Subject: Docket No. 50-206
Provisional Operating License No. DPR-13
Amendment No. 77
San Onofre Nuclear Generating Station
Unit 1

The purpose of this letter is to inform you that several corrections are required to Figures 6.2.2.2 and 5.2-2 to accurately reflect the San Onofre Unit 1 operating staff. These corrections are as follows:

FIGURE 5.2-2 SAN ONOFRE NUCLEAR GENERATING STATION (UNIT 1) ORGANIZATION

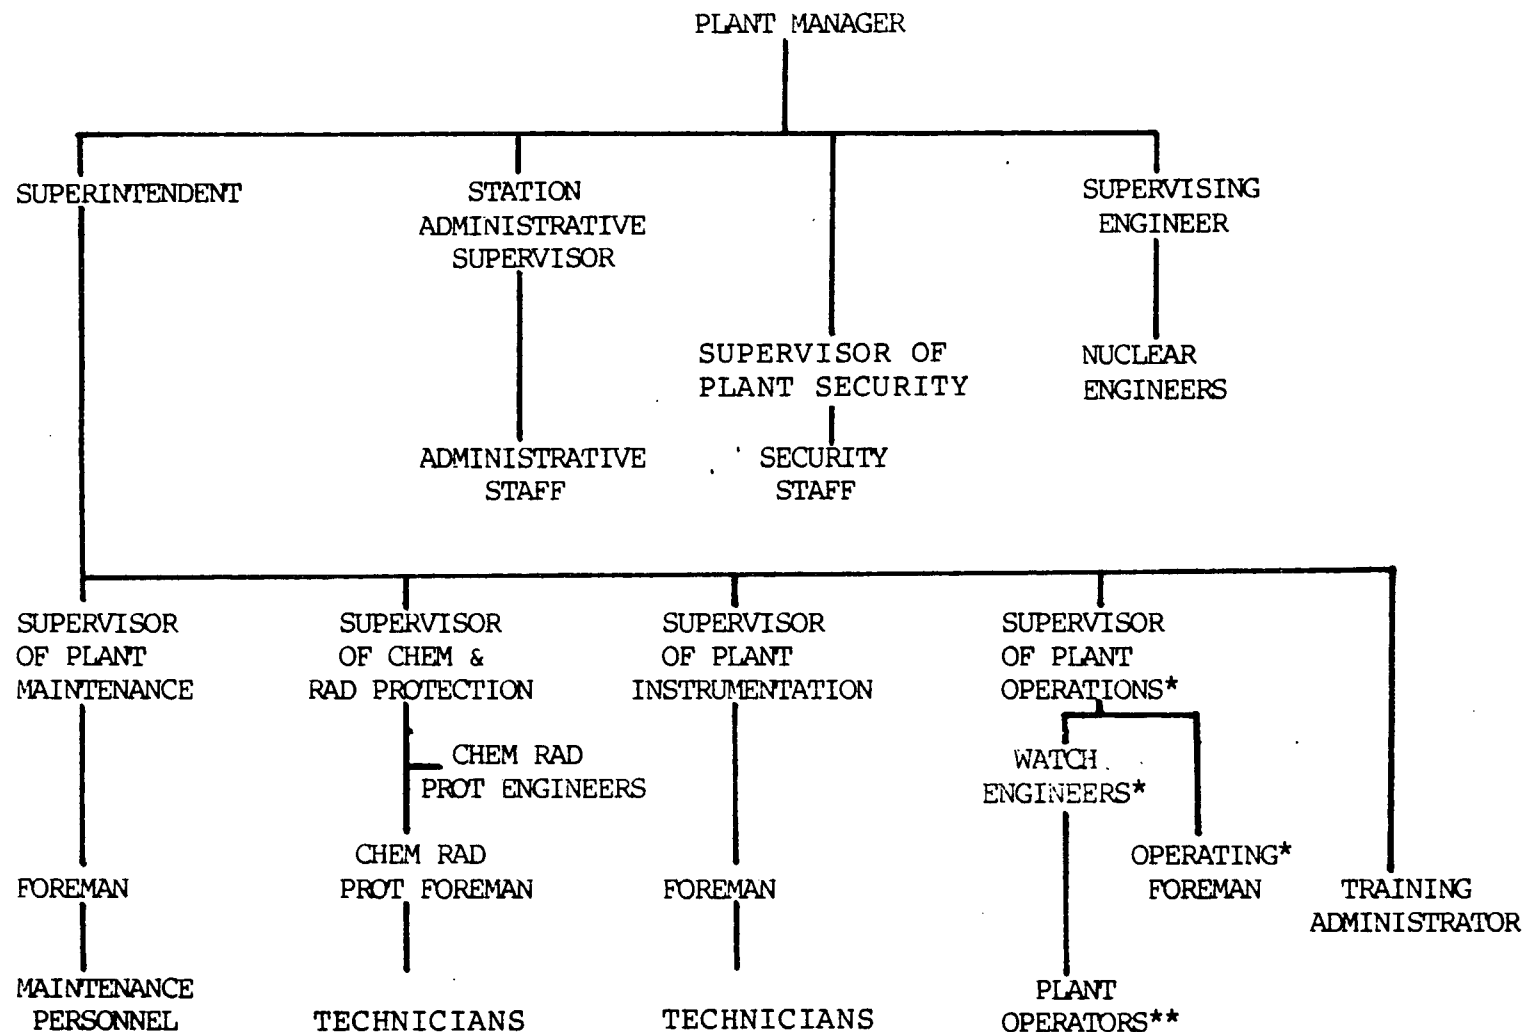
1. Chem Rad Protection is replaced by Technicians, and
2. Instrument Test Technicians is replaced by Technicians.

As requested by members of your staff, enclosed are forty copies of each of the corrected Figures 6.2.2.2 and 5.2-2 which supersede the corresponding figures of Proposed Change No. 77.
